**Droduct Change Notification**

Date Issued :	October 25, 2022	PCN Number :	512817	
Reason for Change :	Change to Product			
Description of Change :	This notification is to inform you about changes that are being made to the part(s) as identified in the list. This change will affect the Fit, Form, Function, or appearance of the parts.			
Reason for Short Notice :	Special Request			
Assessment of Change :	First Article Inspection			
Planned Implementation Date :	January 31, 2023			
Sample Availability Date:	November 10, 2022			
Internal Molex Qualification Date :	November 30, 2022			
Last date to request Samples by Cust	omer: November 11, 2022			
Traceability Code Markings / Date :	Lot information on label			
Before Picture

## After Picture

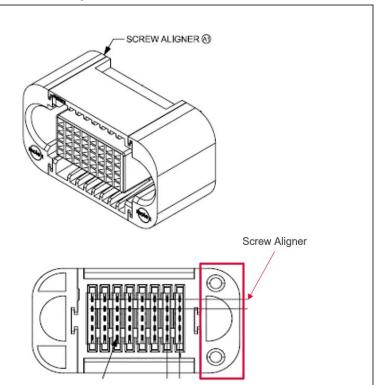
- Molex shall replace Extreme Ten60 BTB Power High-Current Connector <u>right side standard</u> <u>guide/aligner</u> to a screw mount aligner (as highlighted in below image) as part of product improvement
- Product Impact
  - No fit and function attributes changes of the product. Form shall be updated as per pics provided..
- Part Number impacted as per attached impacted part number list
- Qualification report FAI and samples available upon request after the date shown above
